NAVIMFAC PACNORWEST **ORIGINAL IF RED**  
**ENGINEERING MEMORANDUM**

SER. NO.: 841/198M-11

**SUBJECT:** TRIPER/AERP, Low Pressure Air Compressor, Incorrect Rotor

## LPAC Rotor Sketch

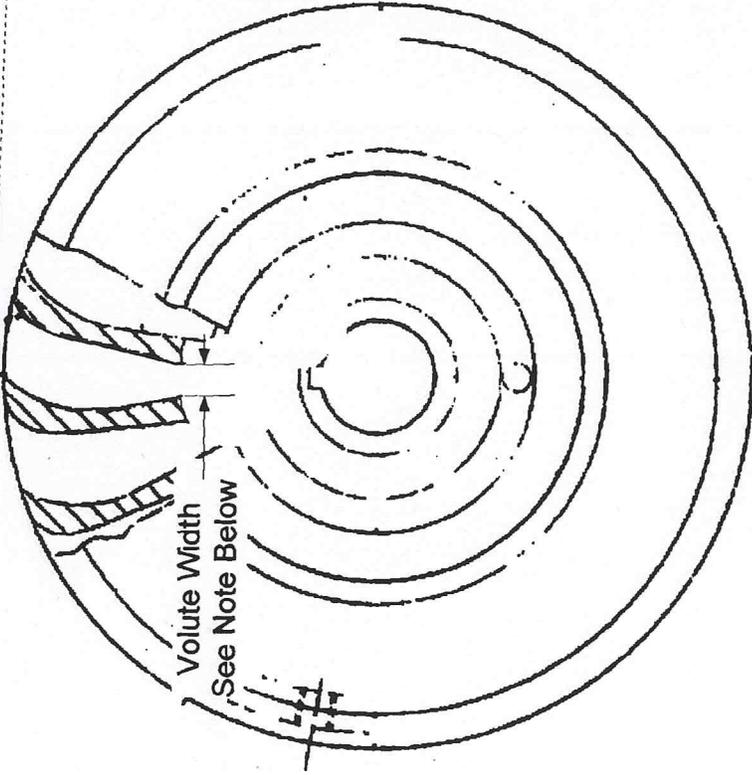
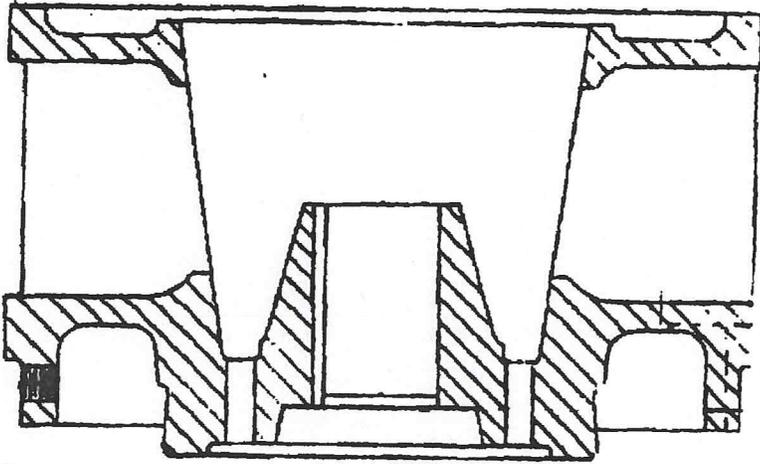
- b. The nominal width of the volute opening in the new rotors (see reference (a) and enclosure (1)) is approximately 3/8" across. This dimension on an in-service rotor marked with the Nash part number is about 1/4". Follow up discussions with Nash POC Mr. John Edman has confirmed the 1/4" wide volute opening best reflects the configuration depicted by the OEM's proprietary drawings.

Note: The width of the volute opening for in-service rotors marked with the Nash part number is 1/4", while the rotors received from supply have a volute nominal width of 3/8".
